Electricity Market Reform: Open letter and consultation on changes to the Capacity Market Rules – response from Moyle Interconnector Ltd

Moyle Interconnector Ltd ("Moyle") owns and operates the 500MW HVDC interconnector between Scotland and Northern Ireland and welcomes this open letter and consultation on changes to the Capacity Market Rules.

Moyle exports to GB

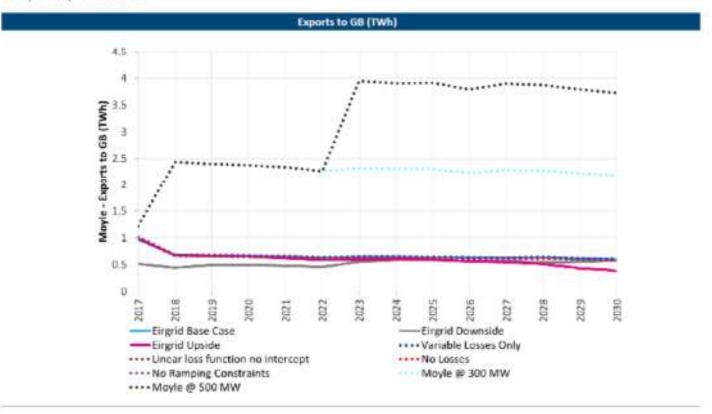
As the chart shows, the extent of Moyle's flows to GB is clearly limited by the TEC assumptions i.e. the underlying economics support more imports to GB than the contracted TEC post 2017 would allow. The lines around the 0.5TWh mark all assume 80MW TEC for all years. The light blue dotted

line shows the 300MW scenario while the darker dotted line shows the 500MW scenario. If flows are not restricted by TEC in line with the points made at 3.2, the modelling therefore suggests that Moyle will provide significant capacity benefit to GB, well in excess of that which was assessed for the 2015 T-4 auction. If Moyle's participation in future capacity auctions is restricted to [De-rating * TEC] then this value will not be recognised, too much capacity will be procured and the GB consumer will pay more than necessary to secure adequate capacity.
